RE: Response to Review Letter of Summary Report

On behalf of the Portland Fuel Facility Corporation (PFFC), Advanced Remediation Technologies, (ART) has prepared this response letter to your review of the Summary Report of ASIG's Bulk Fuel Facility, ECSI No. 1832/5848; Taxiway F, ECSI No. 2240/5849; South Cargo Reload Rack, ESCI No. 5524; and Taxiway T, ESCI No. 5846.

Presented below are responses, clarification, and corrections to DEQ's comments for the Summary Report of ASIG's Group Bulk Fuel Storage Facility Portland International Airport, dated March 13, 2015. The comments, clarification, and suggestions follow the specific comments in italics from the Letter.

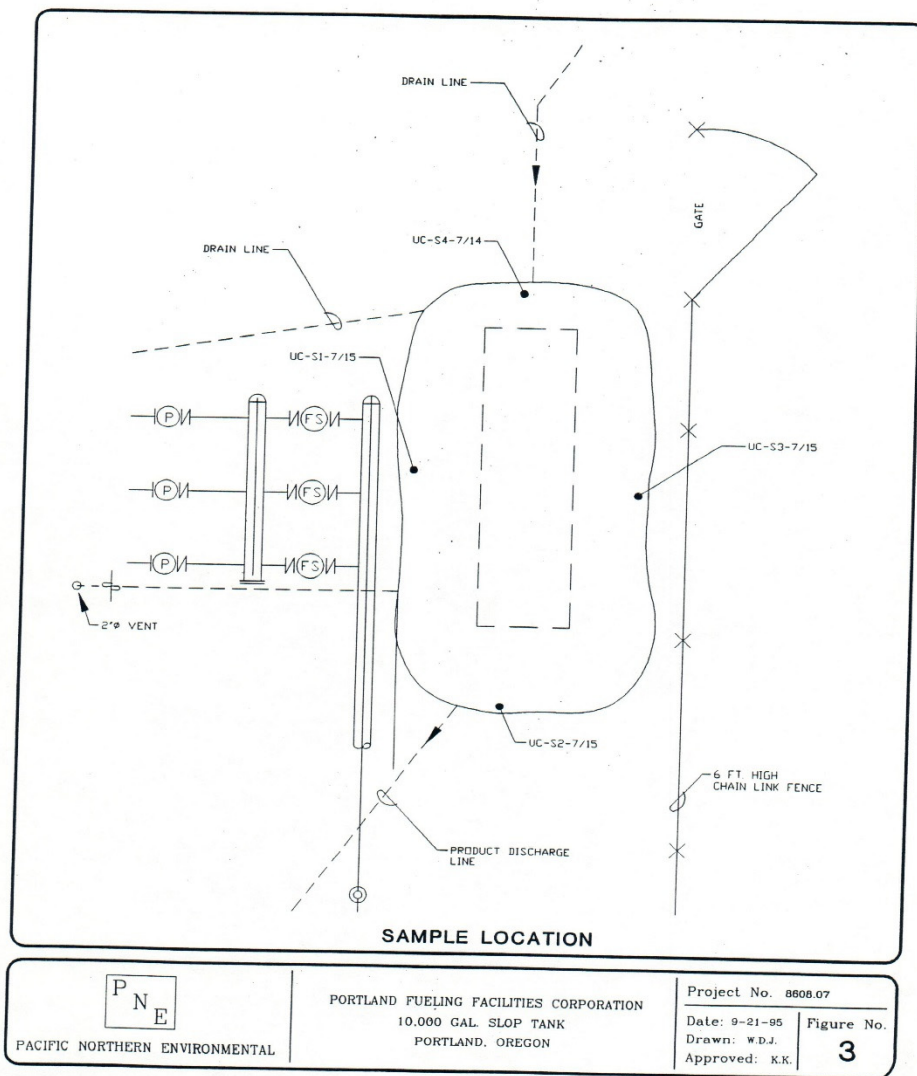
- *Show the location of the UST decommissioned in 1995 with associated remedial extent on a site map.*

Inserted is a figure from the PNE report showing the UST location, extent of removal, and sample locations.

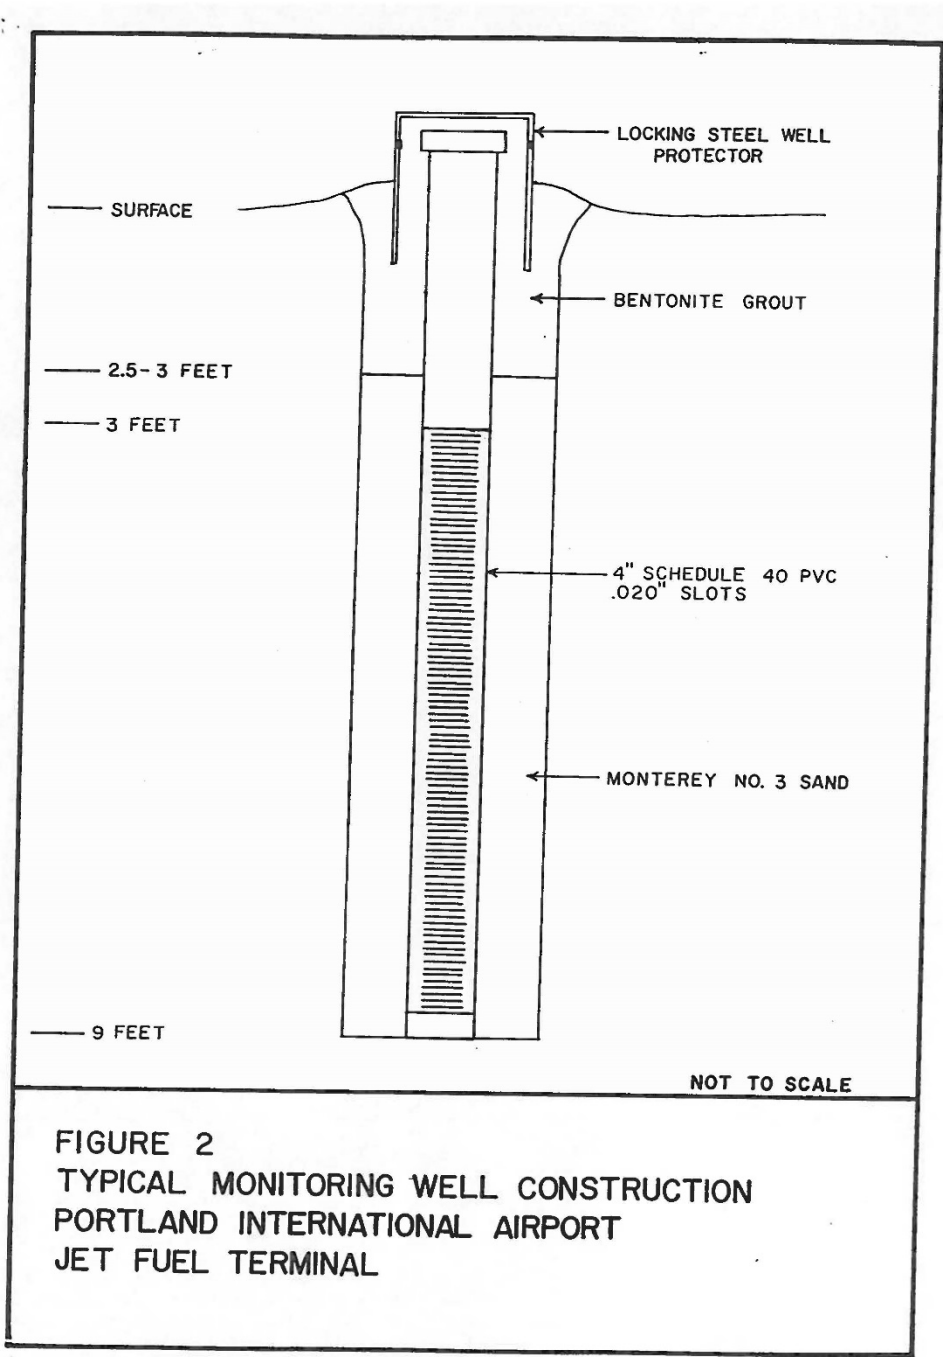
*From field data sheets, of the nine wells monitored and sampled in December 2012, only two (MW-7 and MW-9) had depth to water measurements greater than 5 feet below ground surface (BGS). Conventional monitoring well construction typically includes well slots starting below five feet. If this is the case at this site, petroleum product may not be observable on groundwater closer to the surface than five feet. Please evaluate monitoring well as-built diagrams for the site to determine if this is the case and include these as-built diagrams with the revised Summary Report.*

Inserted are figures from the Reidel and EMCON reports, respectively, showing the monitoring well construction. Based on these logs of the monitoring wells, the wells were constructed with the top of screen approximately 3-feet below ground surface

and extending to the completed depth. If LNAPL was present at the site it would have been easily measured or evident and observed during monitoring events. The field sampling data sheets do not indicate the present of LNAPL.

AIRCRAFT SERVICE INTL GROUP  
 PORTLAND INTERNATIONAL AIRPORT  
 PORTLAND, OREGON  
 JET A TANK FARM, FACILITY PLAN, FIG 3-2A

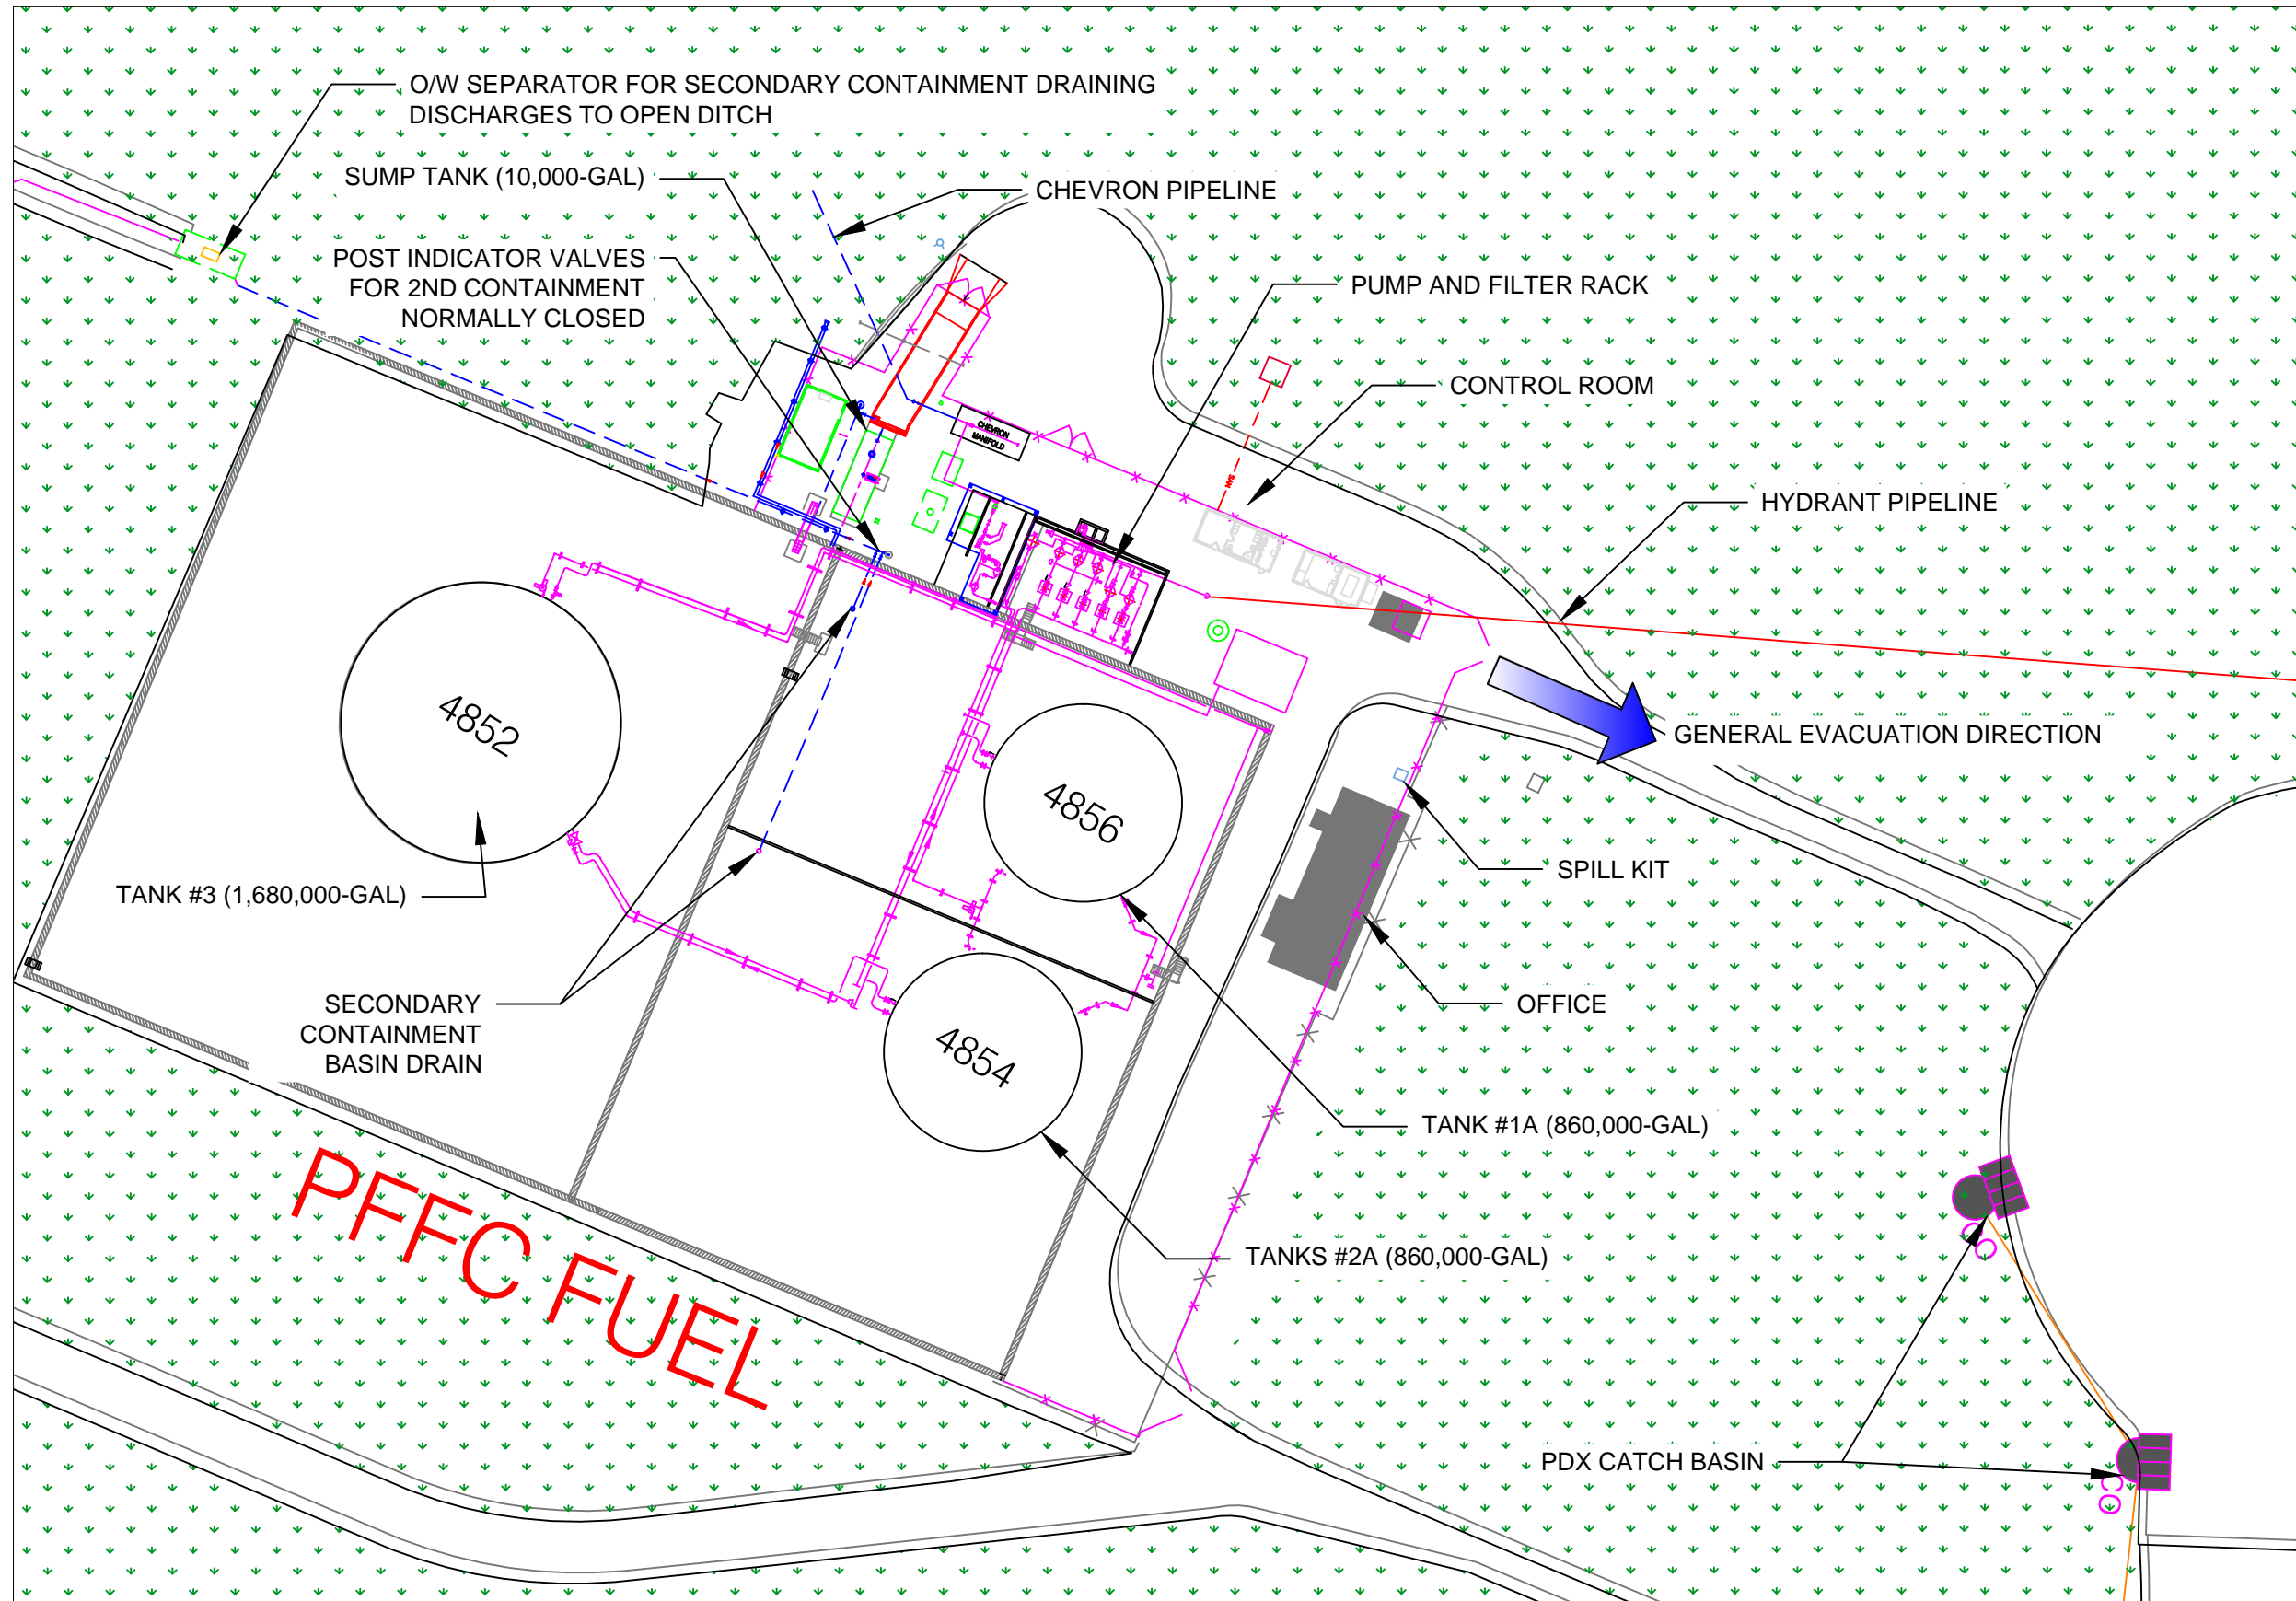
*From the Land and Beneficial Water Use Survey (p. 23), typical groundwater gradient within the surficial fill material at Portland International Airport (PDX) ranges from 0.001 to 0.006. The groundwater gradient calculated for the Bulk Fuel Storage Facility by DEQ using Summary Report Figure 3 data for 12/27/2012 is 0.015. This gradient of 0.015 is 2.5 to 15 times greater than what is expected at PDX. The groundwater flow direction is generally northerly or southerly at PDX while it flows to the west at the Bulk Fuel Storage Facility. This comparison appears to indicate that groundwater flow at the Bulk Fuel Storage Facility is strongly influenced by the deep drainage ditch 200 feet west of the site (see attached aerial photo and APEX 2012, Fig. 2). This drainage ditch appears to control unconfined aquifer groundwater flow in the project area. It is also possible that French drains or other dewatering controls may contribute to the westward groundwater gradient in this area. Include this ditch and any dewatering controls and other utilities on revised site figures.*

*Referring to Figure 3, it appears that the six 1989 site monitoring wells were positioned assuming that groundwater flow was either to the north or to the south. From Chevron 1990 and ART 2012 analysis of groundwater elevation data, groundwater flow direction is to the west. DEQ checked the groundwater gradient calculations using data from Table 3 and field notes and agrees with the westerly flow direction. However, DEQ found that the groundwater gradient is 0.015, not 0.01 as stated in the text. Please make necessary corrections.*

If the ditch controls or strongly influences the groundwater gradient at the PFFC Bulk Fuel Facility, then the gradient should be exactly opposite that which has been measured in the field as indicated by data reported. The historical groundwater gradient measurements have indicated a localized mound in the former excavation of the UST, which is not uncommon. This is most likely the result of backfilling with 3-inch minus and ¾ minus rock which is more transmissive than the sandy silt encountered at the site and what surrounds the former UST excavation.

Table 3 shows a summary of groundwater monitoring results for elevation and BTEX. Table 2 shows a summary of groundwater monitoring results for PAH's and TPH. Figure 3 shows groundwater contours and inferred gradient for December 27, 2012 elevation data. Groundwater tends to the west and north-northeast with a gradient of approximately 0.015. This data is consistent with groundwater flow directions reported by previous monitoring events.
